**MONTGOMERY COUNTY HISTORIC PRESERVATION COMMISSION**  
**STAFF REPORT**

**Address:** 10304 Montgomery Avenue, Kensington      **Meeting Date:** 3/20/2024  
**Resource:** Primary Resource      **Report Date:** 3/13/2024  
**Kensington Historic District**  
**Applicant:** Jeff and Gloria Capron      **Public Notice:** 3/6/2024  
(Luke Olson, Architect)  
**Review:** Historic Area Work Permit      **Tax Credit:** Partial  
**Permit Number:** 1060765      **Staff:** Chris Berger  
**PROPOSAL:** Fenestration alteration, new additions, hardscape alterations, construction of new detached garage.

Staff recommends that the Historic Preservation Commission (HPC) **approve with five conditions** the HAWP application with final review and approval of all details delegated to staff:

Figure 5: The proposed site plan shows the location of the proposed addition, arway, and deck clouded in red.

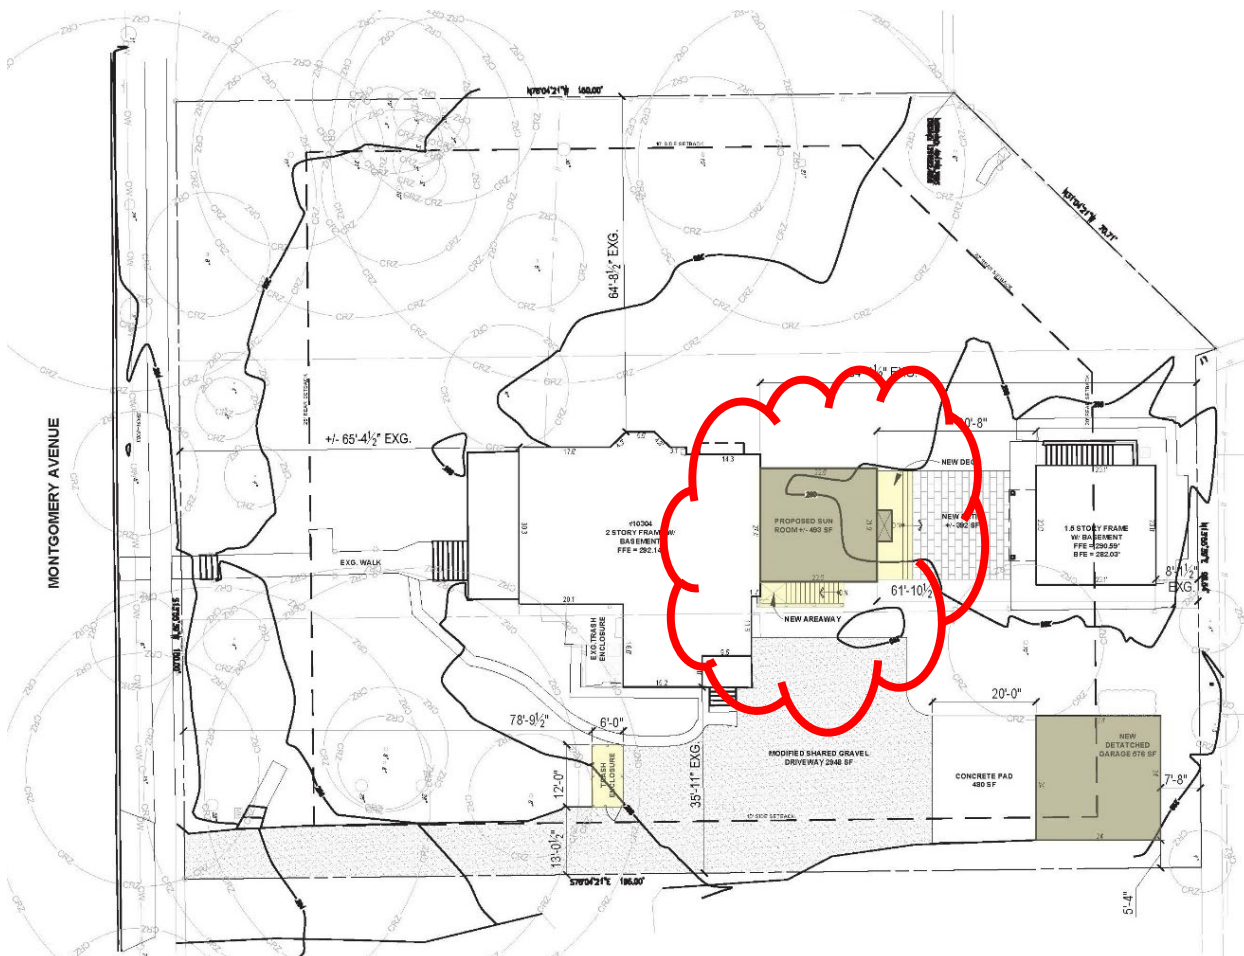
The applicant proposes a one-story, 493-square-foot rear addition on the rear elevation (*Figures 4-9*). The plan reviewed by the HPC as part of the preliminary consultation included a screened porch that was visible from the right of way, but the applicant has removed the porch from the proposal.

An approximately 75-square-foot areaway will extend parallel along the right-side elevation to access the proposed basement expansion under the addition. A composite railing will line its perimeter. The areaway proposed as part of the preliminary consultation was to be perpendicular to the addition. A pad and walkway to the areaway are not present on the plans, so if they are to be added they need to be part of a future HAWP application.

An approximately 100-square-foot deck will extend the length of the rear addition. This new deck location is in response to the HPC's comments in regard to the previous design of the deck proposed as part of the preliminary consultation. The deck will have Aeratis flooring and stairs and composite railing.

Staff supports the proposed rear addition with areaway and deck and recommends approval. The removal of the proposed screened porch improves the combability of the new construction. Staff finds its overall scale, massing, and form to be compatible as it remains secondary and subservient to the historic house because of its one-story scale. Further, most of the elements would have limited to no visibility from the public right-of-way due to their setback from the street and location behind the house, where they will be inset. Staff finds the proposed materials to be compatible with the historic house and surrounding district. The HPC routinely approves the use of cementitious siding, PVC trim, and asphalt shingle roofs on additions. The work meets both Kensington's Master Plan *Amendment* and *Vision*. In accordance with Chapter 24A-8(b), the proposal will not substantially alter the exterior features of an historic resource within an historic district, and the work is compatible in character with the historic district where rear additions as proposed are common. Per Chapter 24A-8(d), the HPC is to be lenient in its judgement for plans involving new construction unless they would seriously impair the historic or architectural value of the surrounding historic resources or would impair the character of the district. Staff finds the addition will not affect the value and character of the district. It also conforms with the *Standards*, because the historic character of the property will be retained and preserved; the new addition will not destroy the historic materials that characterize a property and the new will be differentiated from the old; and the form and integrity of the property will be unimpaired if the addition is removed in the future.

Figure 10: The proposed site plan shows the location of the proposed garage clouded in red.

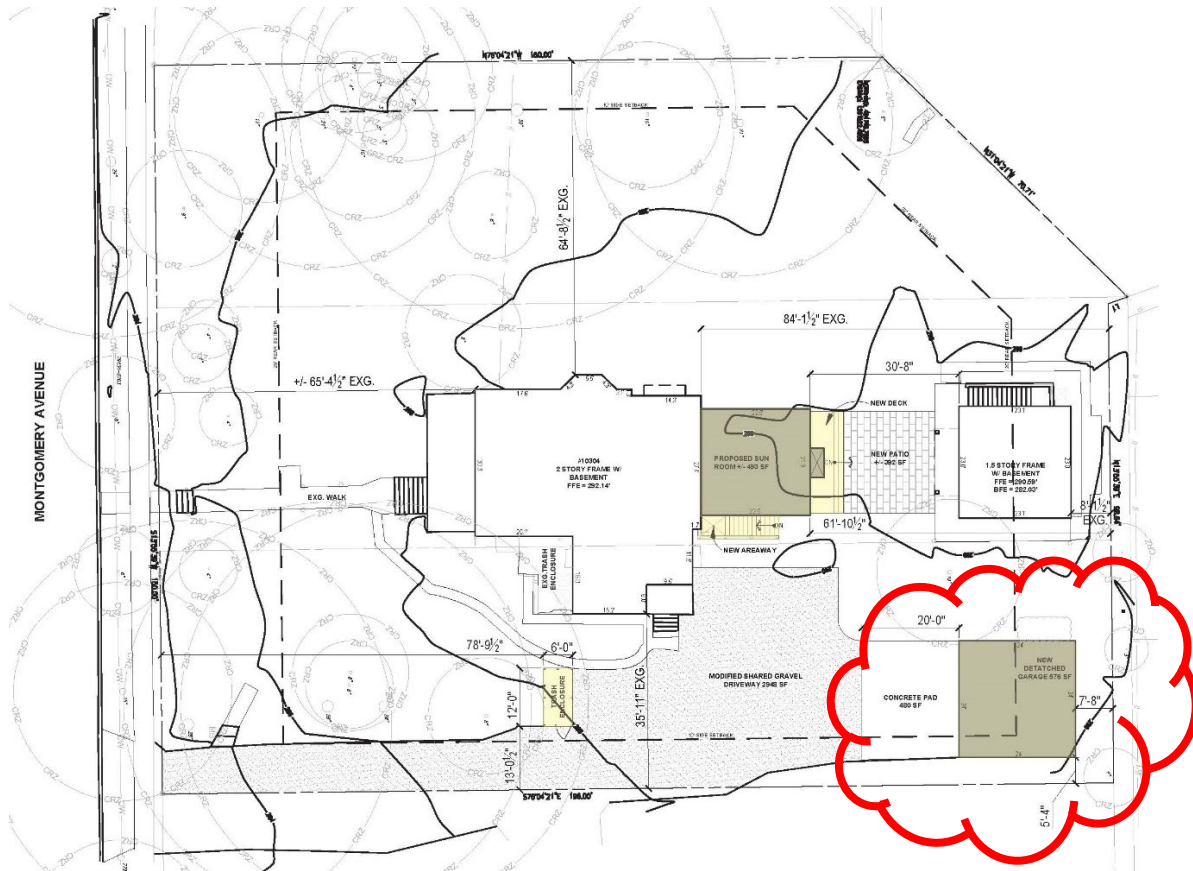
The garage plan reviewed by the HPC as part of the preliminary consultation included a cupola, but the HPC directed the applicant to remove it, and the applicant has complied. The applicant also was to study gable roof forms for the garage and select an option that minimized its appearance. The applicant's architect said he completed the study and determined that the hipped roof was the best option to minimize the garage's appearance because it has a smaller profile compared to a front or side-gabled roof. He noted that the existing residence on the property has a hipped roof, so there is precedent for the roof type on the property.

The HPC also directed the applicant to ensure placement of the garage was compatible and sensitive to the location of the adjacent historic accessory structure at 10308 Montgomery Avenue. The applicant's architect noted that the two-story accessory structure on the adjacent property is set back 7.5 feet off the rear lot line and measured 18 feet long. The proposed garage will have a similar rear setback and will be 24 feet long. The garage will be set forward to address HPC's direction to minimize impact to trees. According to the architect, the garage's location was selected because it is a clear area currently occupied by a gravel driveway. The proposed garage will be set back 164 feet from the front property line, so the six-foot projection difference between the buildings would not be evident from the right of way.

Staff supports the proposed garage and recommends approval. The hipped roof is less visually imposing than a gable roof and matches a roof type found on the historic residence. The garage will be smaller in massing than the 1.5-story historic accessory structure on the subject property and two-story accessory structure on the adjacent property at 10308 Montgomery Avenue. The garage will be set well back from the right of way to limit its visual impact, and its siting protects existing trees along the rear property line. The historic record supports the construction of multiple accessory structures on lots. Staff finds that the materials of the garage to be compatible with the individual resource and the historic district; the HPC regularly approves the use of cementitious fiberboard siding, PVC trim, and asphalt shingles. The work meets both Kensington's Master Plan *Amendment* and *Vision*. In accordance with Chapter 24A-8(b), the proposal will not substantially alter the exterior features of an historic resource within an historic district, and the work is compatible in character with the historic district where accessory structures in the rear yard are common. Per Chapter 24A-8(d), the HPC is to be lenient in its judgement for plans involving new construction unless they would seriously impair the historic or architectural value of the surrounding historic resources or would impair the character of the district. Staff finds the garage will not affect the value and character of the district. It also conforms with the *Standards*, because the historic character of the property will be retained and preserved; the new garage will not destroy the historic materials that characterize a property and the new will be differentiated from the old; and the form and integrity of the property will be unimpaired if the garage is removed in the future.

**Figure 12: Hardscape alterations include a 480-square-foot concrete pad in front of the proposed garage, a 392-square-foot patio, and gravel driveway reconfiguration.**

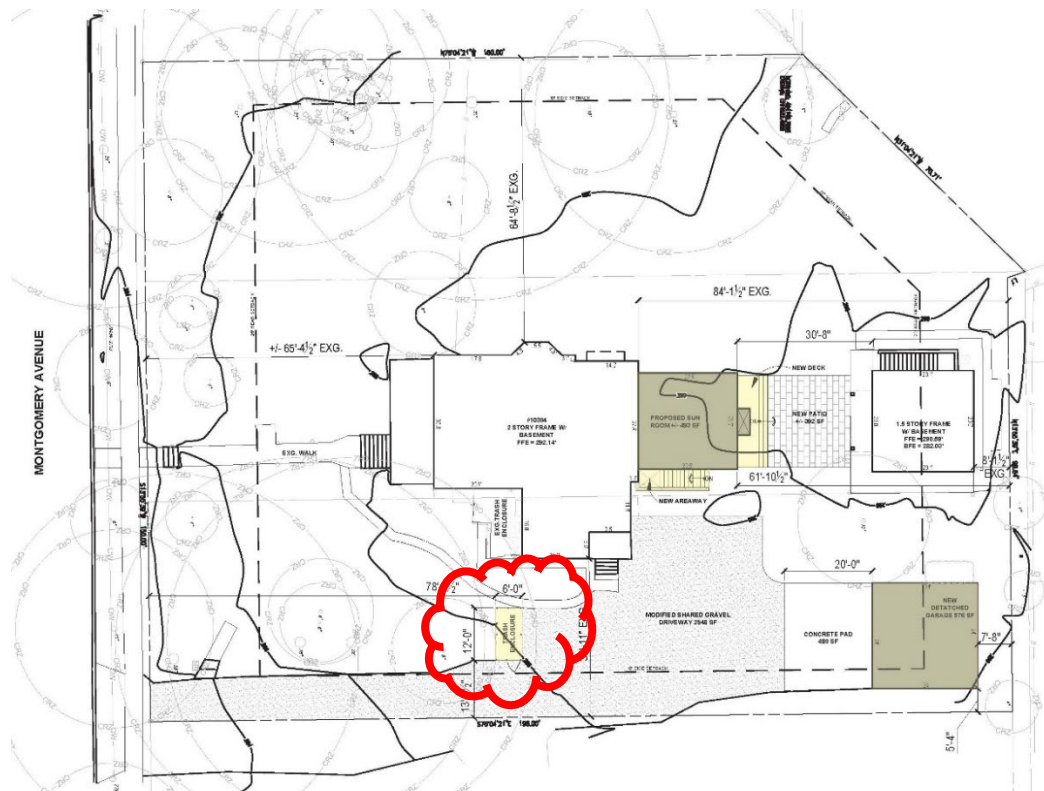
The applicant proposes to construct a 480-square-foot concrete pad in front of the proposed garage, a 392-square-foot patio, and reconfigure the gravel driveway (*Figure 12*). According to the plan, the existing gravel driveway measures 2,936 square feet and extends to the existing carriage house. The proposed driveway will be reconfigured to remove the section that extends to the existing carriage house. Gravel will be added to provide parking along the existing residence. The new driveway will measure 12 additional square feet. The HPC expressed concern about the increased hardscape as part of the preliminary consultation, so the applicant removed the stone wall. Staff seeks a condition that the applicant provide specifications for the proposed patio material.

Staff supports the proposed hardscape alterations and recommends approval. A net of approximately 1,300 square feet—or 5 percent—of the existing 28,367-square-foot lot will be covered by both new construction and new hardscape. It all will be built in the rear yard where it will be at most minimally visible from the right of way. Those improvements include the rear addition, areaway, deck, garage, concrete pad, and trash enclosure for a total of 1,800 square feet. An existing slate patio measuring approximately 500 square feet will be removed and returned to greenspace. The hardscape work meets both Kensington’s Master Plan *Amendment* and *Vision*. In accordance with Chapter 24A-8(b), the hardscaping will not substantially alter the exterior features of an historic resource within an historic district, and the work is compatible in character with the historic district where hardscaping as proposed in are common. Per Chapter 24A-8(d), the HPC is to be lenient in its judgement for plans involving new construction unless they would seriously impair the historic or architectural value of the surrounding historic resources or would impair the character of the district. Staff finds the hardscape improvements will not affect the value and character of the district. The work also conforms with the *Standards*, because the historic character of the property will be retained and preserved; the new hardscape will not destroy the historic materials that characterize a property and the new will be differentiated from the old; and the form and integrity of the property will be unimpaired if the hardscape is removed in the future.

**Figure 16: The applicant proposes to replace the front and right-side porch floors with Aeratis and replace the railing and stairs on the right-side porch.**

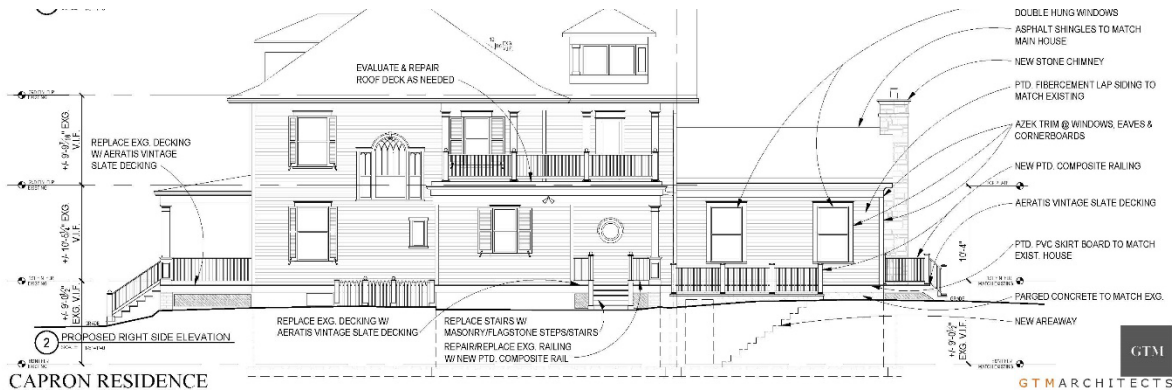
The applicant seeks to replace the existing wood tongue-and-groove decking on the front and right-side porches with Aeratis heritage paintable tongue and groove decking (Figures 15-16). The applicant’s justification is to increase the longevity of the deck, which has experienced wood rot. On the right-side porch, the applicant also seeks to replace the wood railing and steps with painted composite railings and brick and flagstone steps to provide a more durable solution in the high-traffic area.

Evaluating the proposal under Chapter 24A, Staff finds the proposal to change the wood porch decking on the original porch to a non-wood material is an inappropriate substitute material and recommends the HPC deny the work item under 24A-8(a). Staff finds that the proposed porch replacement will substantially alter the exterior features of a historic resource, contrary to 24A-8(b)(1). Staff additionally finds the proposed material is not a compatible substitute for wood decking for original front porches in the Kensington Historic District and does not meet 24A-8(b)(2). Staff does not find the proposed work will provide additional protection for the site under 24A-8(b)(3), nor that the existing condition is unsafe or a health hazard as generally understood under 24A-8(b)(4). Staff finds that property owners will not be deprived of reasonable use or suffer “undue hardship” of their property under 24A-8(b)(5) if the work is not approved. Staff does not find that in applying a balancing test, the public is better served by granting

Staff supports the Hampton composite railing and brick and flagstone steps for the right-side porch. The side porch was constructed in the 1980s, so per Chapter 24A-8(d) the HPC is to be lenient in its judgement of the plans unless such plans would seriously impair the historic or architectural value of the surrounding historic resources or impair the character of the district. Staff finds this would not be the case with the proposed changes. The applicant’s architect noted the existing front- and right-side porches are on brick piers, so the proposed materials match those already found on the historic resource. Staff seeks a condition that the applicant provide a detail for the replacement side porch. The proposed replacement materials on the side porch meet both Kensington’s Master Plan *Amendment* and *Vision*. In accordance with Chapter 24A-8(b), the proposal will not substantially alter the exterior features of an historic resource within an historic district, and the work is compatible in character with the historic district where synthetic materials on rear additions are common. It also conforms with the *Standards*, because the historic character of the property will be retained and preserved; the new enclosure will not destroy the historic materials that characterize a property and the new will be differentiated from the old; and the form and integrity of the property will be unimpaired if the synthetic porch materials are removed in the future.

**1 PROPOSED FIRST FLOOR PLAN**  
SCALE: 1/8"=1'-0"

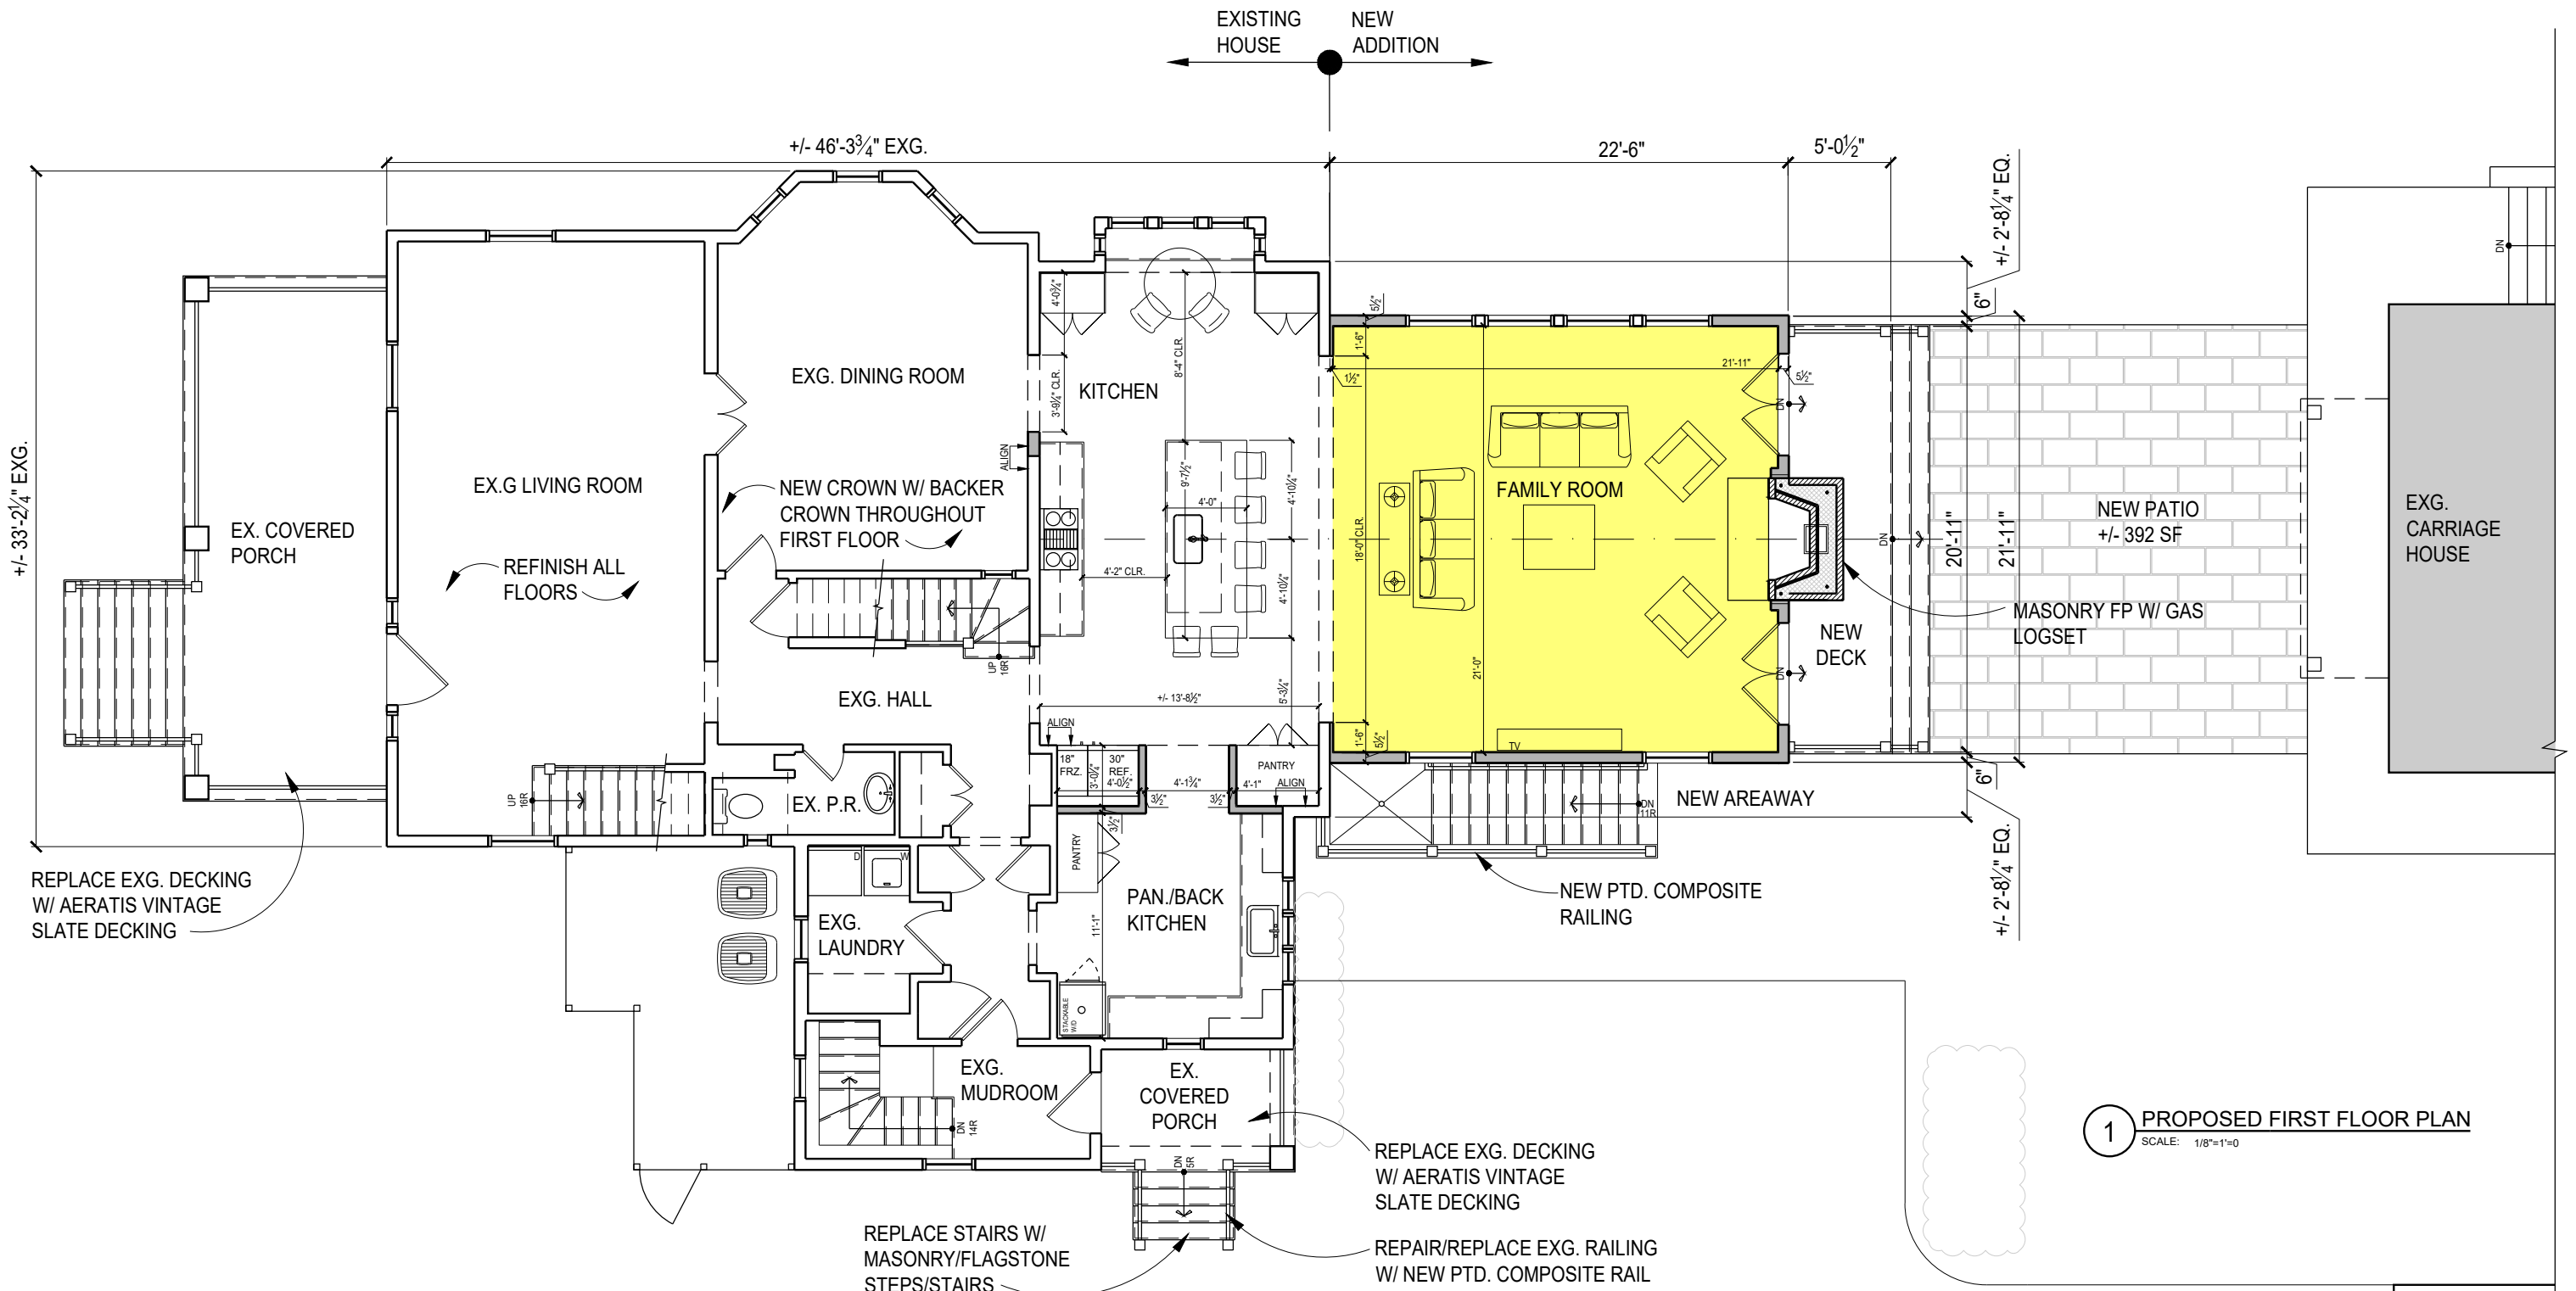
- The Proposed First Floor Plan sheet references a 140 square foot rear porch in the square footage table. Please clarify what that is referencing.
- Please confirm whether or not the replacement windows on the second floor of the rear elevation will be smaller in size than the existing and will have Azek trim.
